INDIANA DEPARTMENT OF TRANSPORTATION

AGENDA

February 21, 2013 Standards Committee Meeting

RE: Agenda for the February 21, 2013 Standards Committee Meeting

805-SGCF-04 SIGNAL HANDHOLE, TYPE I CONCRETE (DRAFT)

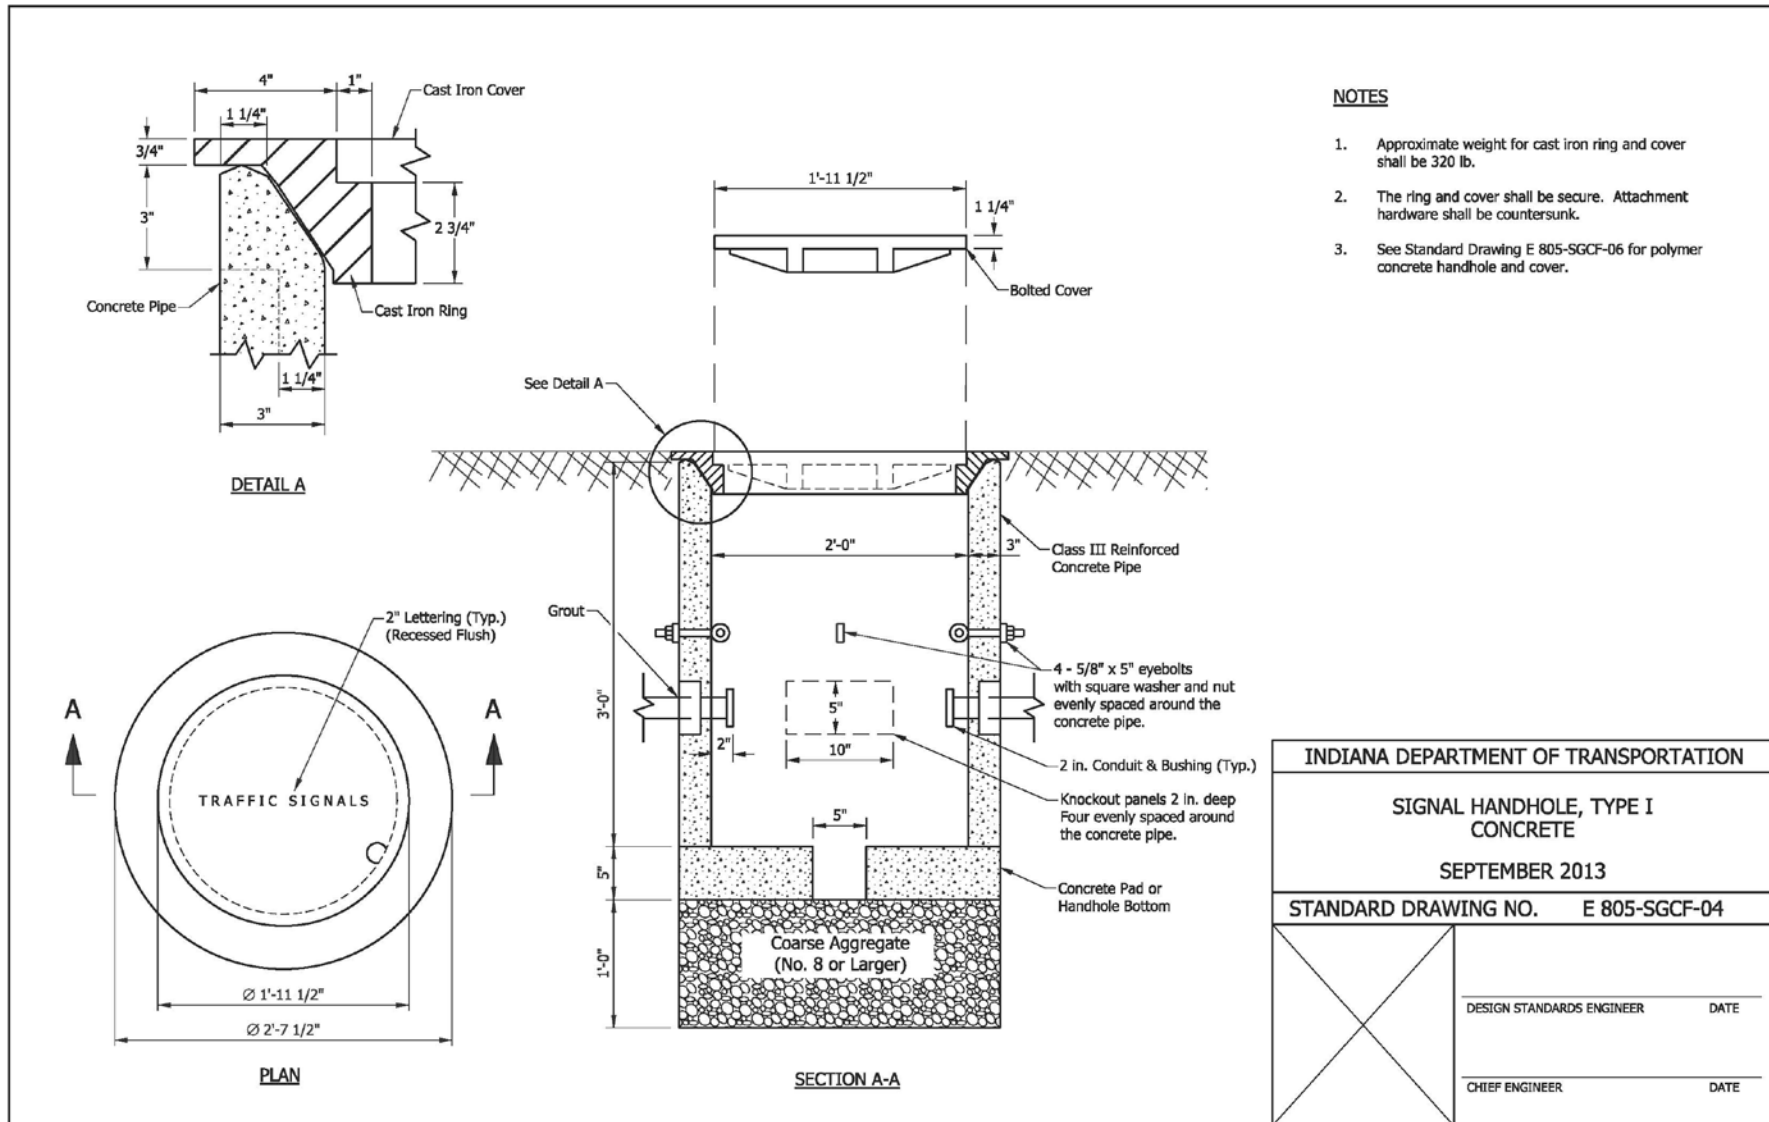
Revise Standard Drawing 805-SGCF-04 for concrete handholes and create a version for polymer concrete handholes. Delete Standard Drawing 805-SGLT-01.

805-SGLT-01 LOOP TAGGING SYSTEM (PROPOSED TO DELETE)

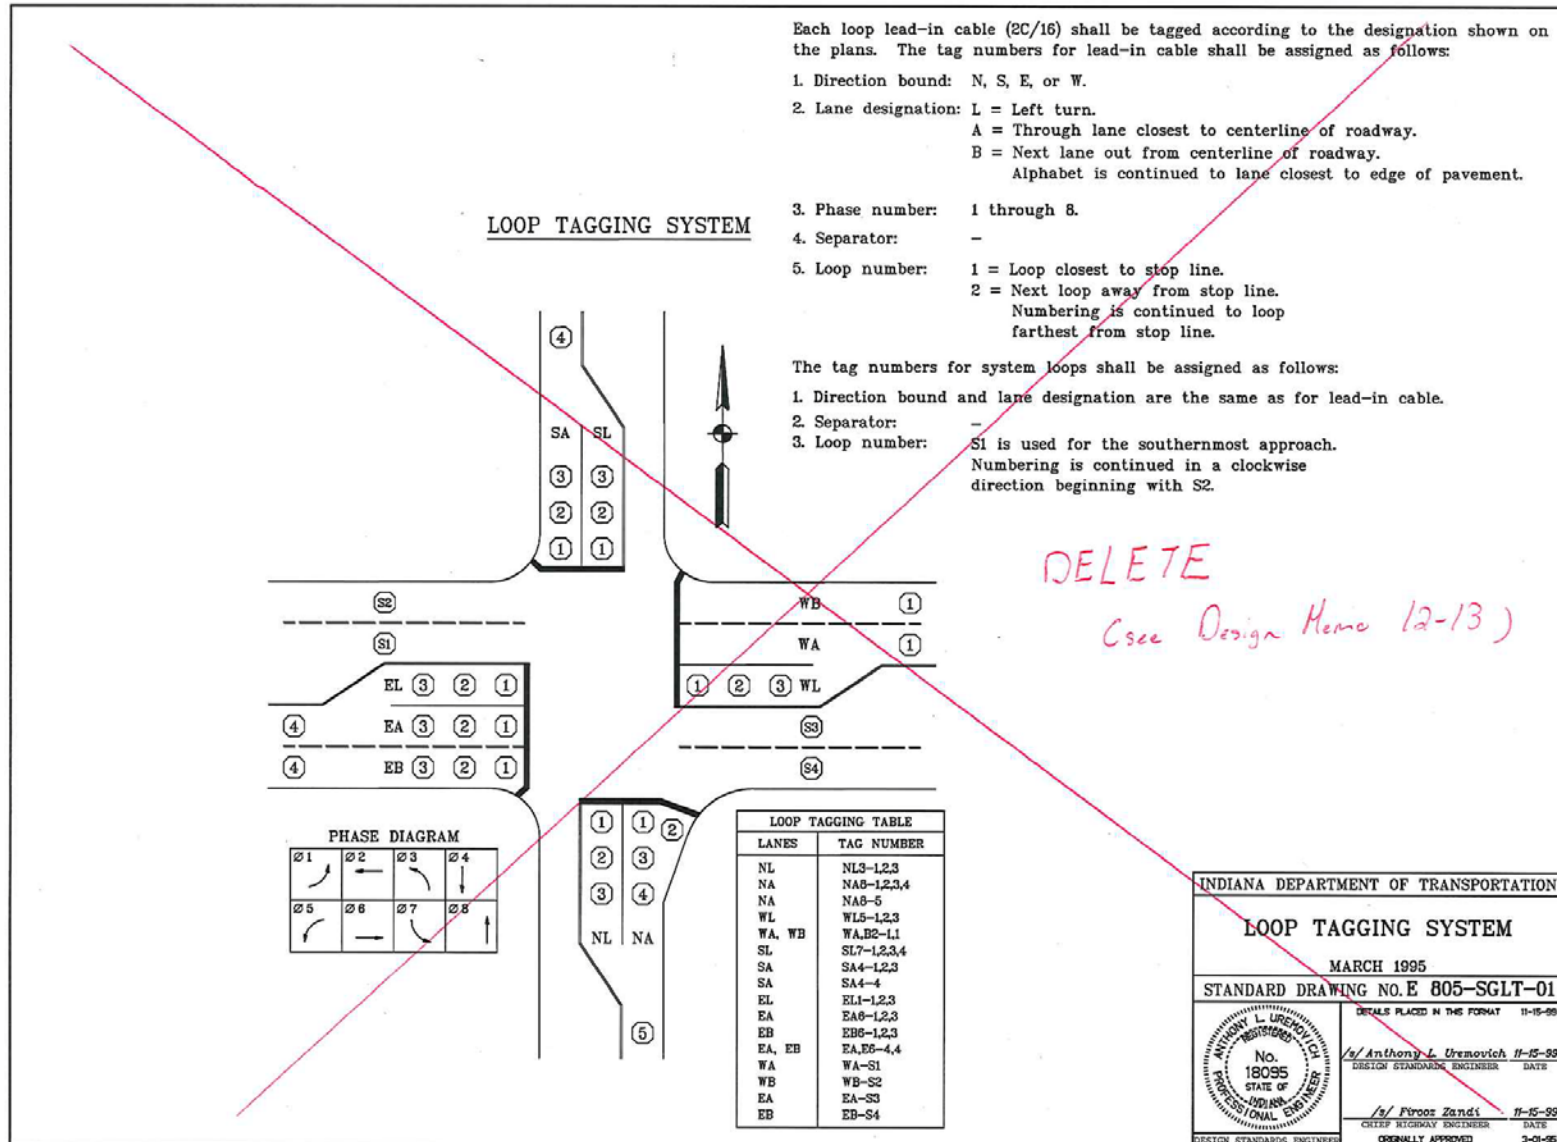
Standard Drawing 805-SGLT-01 detailing the loop tagging table is not accurate and is redundant since the designer provides this information (see Design Memo 12-13).

731-MSEW-01 MSE WALL CAST-IN-PLACE CONCRETE COPING (DRAFT)

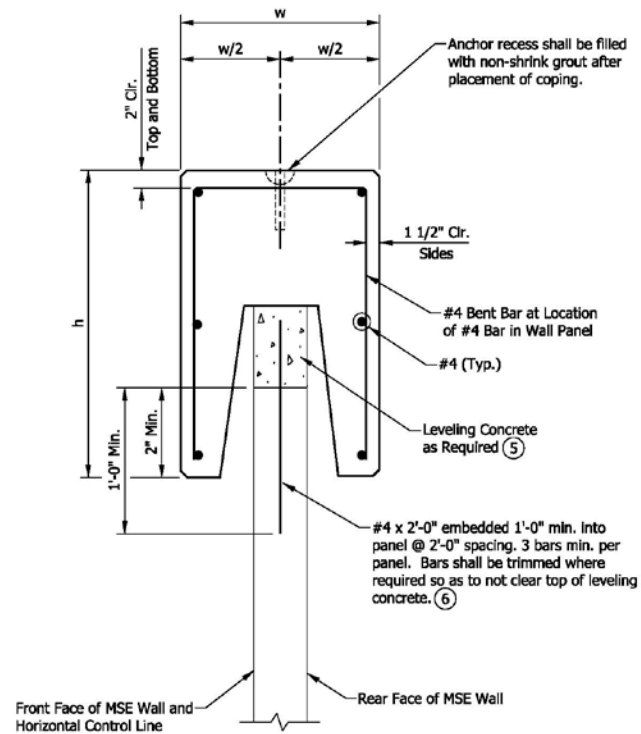
PROPOSED SOLUTION: Add notes clarifying use of leveling concrete to Standard Drawing 731-MSEW-01. No changes are proposed for the remaining drawings in the 731-MSEW series. No changes are proposed to the related Standard Specification 731 or active Recurring Special Provision 731-R-597. Leveling concrete will continue to be considered an "incidental" wall material and should be included in the cost of Face Panels, Concrete per 731.13.

1. Precast coping unit length shall be 10'-0".
2. Reinforcing bars' size, length, and spacing shall be determined by the manufacturer.
3. All chamfered edges shall be 3/4".
4. See Standard Drawing E 703-BRST-01 for reinforcing-bar bending details and notes.
- ⑤ Leveling concrete shall be Concrete, Class A. Leveling concrete is required when adjacent top panels do not provide a continuous surface on which to place the precast coping, e.g., stepped panels or rectangular panels on a sloping grade. Leveling concrete is not required when custom top panels provide a surface parallel to the finished grade.
- ⑥ Use only when leveling concrete is required.

BACKUP 01. IDM, FIGURES 404-2B and 404-2C

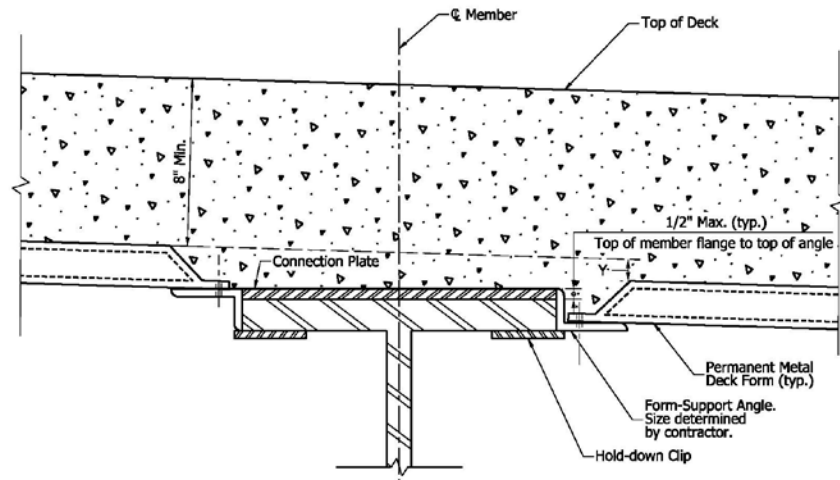
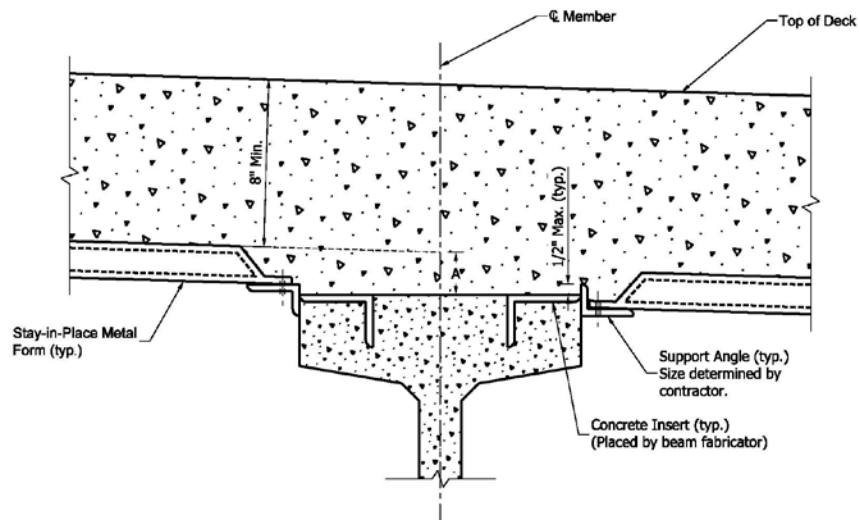
2. The improper installation of stay-in-place (SIP) metal deck forms can cause cracking. Limiting the projection of the form support above the top flange to 1/2 inch is considered adequate to reduce the likelihood cracks. Figures 404-2B and -2C illustrate the connection of SIP forms and instructs the designer to detail the connection on the plans. Because the engineer of record is not responsible for the design for the SIP forms, the plans are not the appropriate place for this information.

PROPOSED SOLUTION: Incorporate the proposed changes into the 702 section and to amend section 702.13 (e) 2. to limit the projection of the form support to a maximum of 1/2 in. above the top flange. Revise the Design Manual to refer to Figures 404-2B and -2C as typical connections and delete the requirement to detail the connection on the plans.
